MIL-R-83536/11
AMENDMENT 2
30 September 1996
SUPERSEDING
AMENDMENT 1
15 December 1995

MILITARY SPECIFICATION SHEET

RELAYS, ELECTROMAGNETIC, ESTABLISHED RELIABILITY, DPDT,
LOW LEVEL TO 10 AMPERES, PERMANENT MAGNET DRIVE,
HERMETICALLY SEALED, ALL WELDED, AC COILS

SOCKET PIN

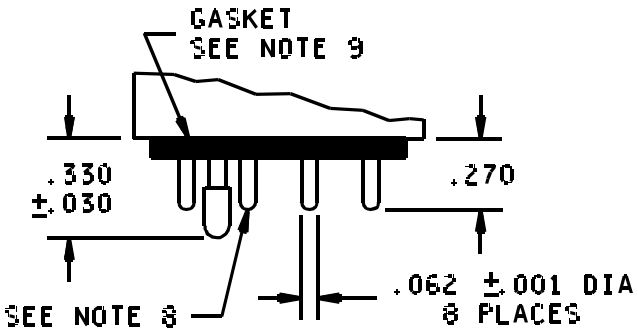
FIGURE 1, socket pin diagram, delete and substitute:
